Conceptual Site Plan Glenwood Hills

CSP-88020-03

STAFF REPORT

SUBJECT: Conceptual Site Plan CSP-88020-03
Type 1 Tree Conservation Plan TCP1-066-94-03
Glenwood Hills

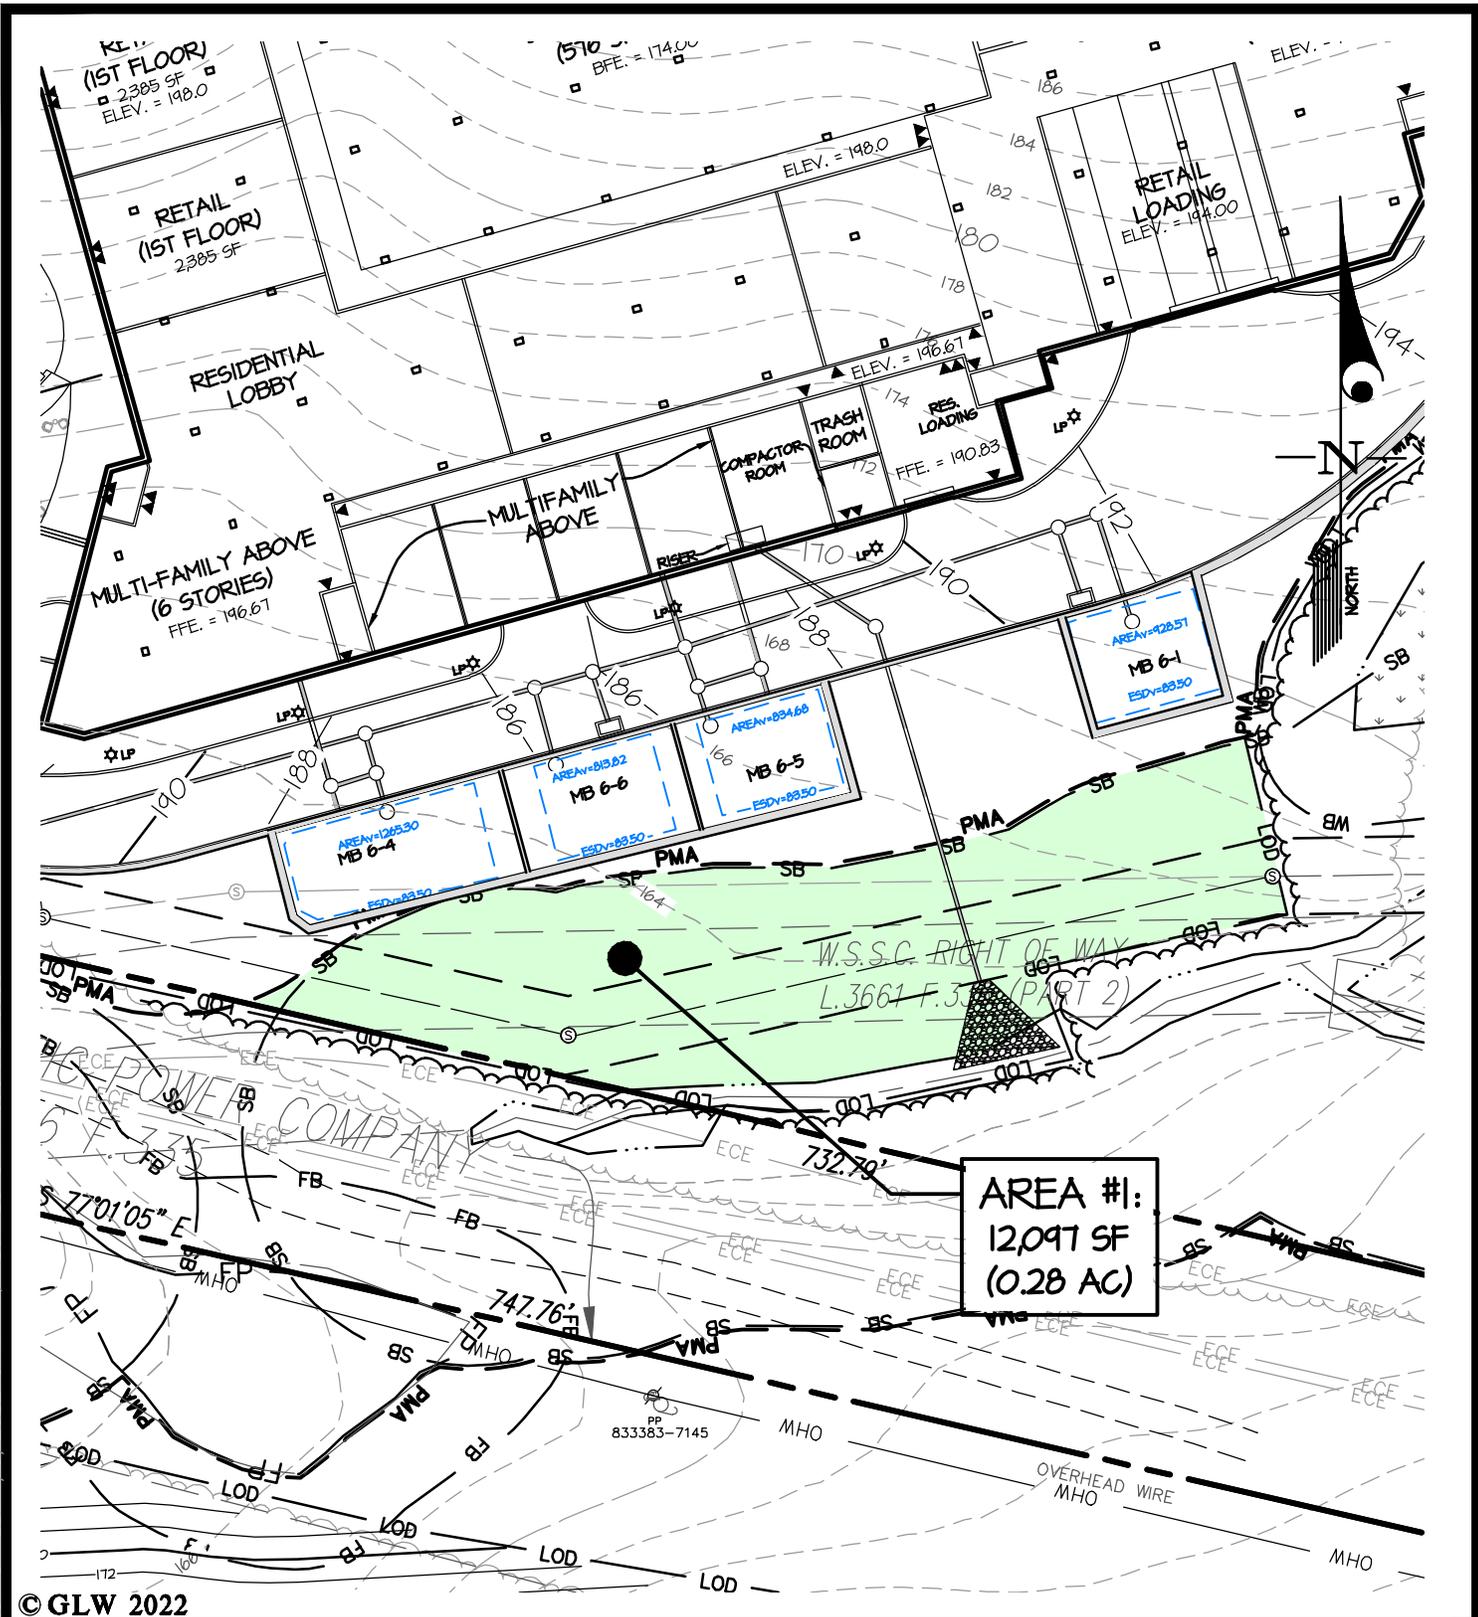
Impact #11 is 2,558 square feet (0.06 AC) of PMA disturbance for a bridge abutment installation associated with Karen Boulevard.

Karen Boulevard is a four (4) lane, 80' wide collector road with an 8' side shared use path, sidewalks and on road bike lanes and shown in the 2010 Subregion 4 Master Plan. Due to the three (3) existing perennial streams that cross the subject property and the need to connect to Central Avenue, PMA impacts are unavoidable. In an effort to reduce impacts, road alignment, road profile and bridge construction strategies were employed to reduce or mitigate impact to the regulated environmental features.
